Reply on RC2

Author comment on "The impact and resolution of the GPS week number rollover of April 2019 on autonomous geophysical instrument platforms" by Shane Coyle et al., Geosci. Instrum. Method. Data Syst. Discuss., <https://doi.org/10.5194/gi-2020-47-AC2>, 2021

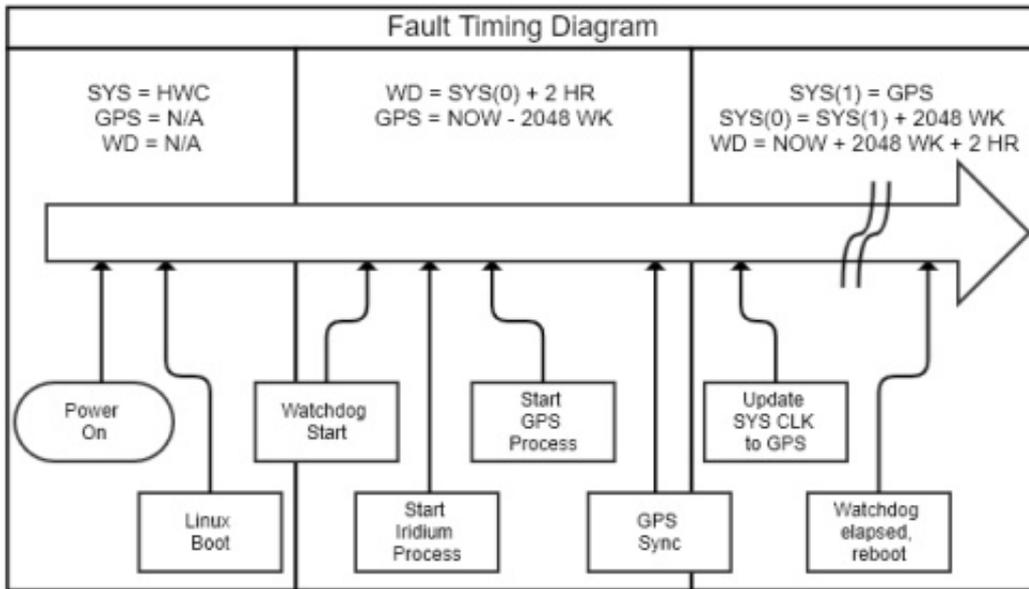
RE: Figure 2 (previously), the subsystem diagram,
- The difference in the figures is more than just an additional line from Iridium to the system clock. The hardware clock now feeds the watchdog in stead of the system clock as well.

Though we could provide great technical detail for this fault, it remains the intent of the authors to provide a high level summary in order to focus more on general design guidelines. However, because the sequence of timing is critical to the occurrence of the fault, we have included a new figure summarizing the process of clock synchronization on AAL-PIP (new Figure 2, attached).
